**Letter of Notification
East Akron-Hanna 138 kV Transmission Line Tap
To Old Forge Substation
Case No. 13-0108-EL-BNR**

OLD FORGE
SUBSTATION

EXHIBIT 5A

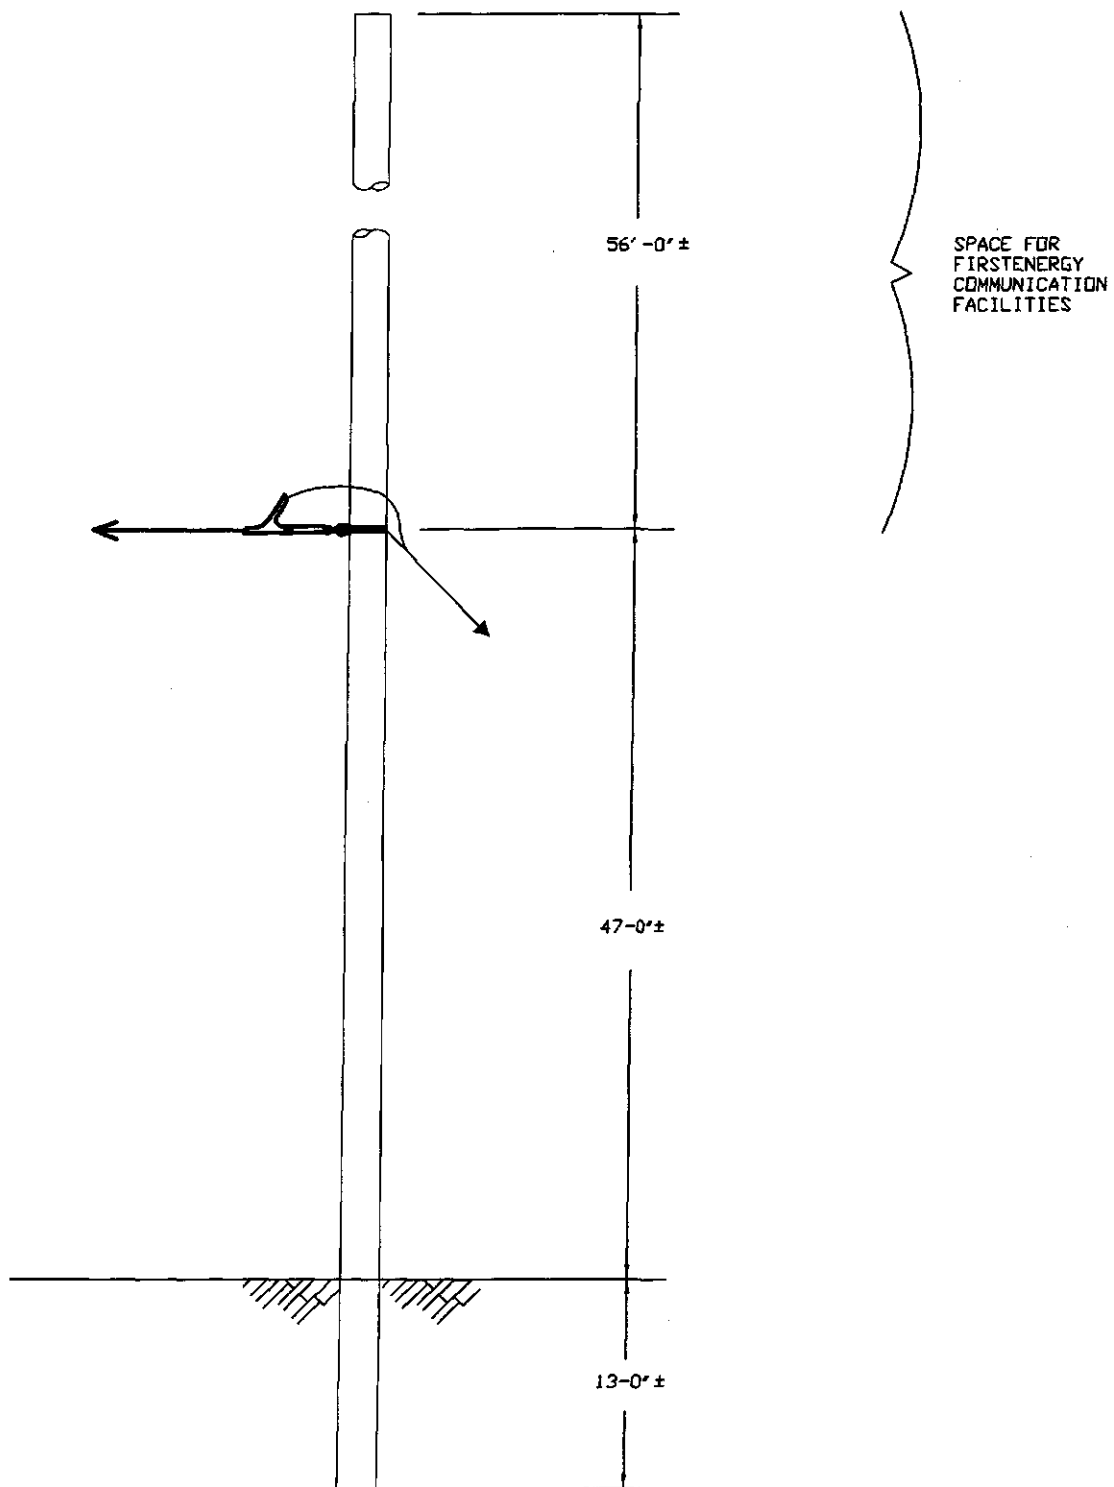
The supplemental engineering information conveyed in Exhibit 5A indicates that the static wire structure will be 115 feet in height rather than 55 feet in height. The change is being made to accommodate communication equipment within the Old Forge Substation. The location of the pole has not changed. All other structures and features of the project remain the same.
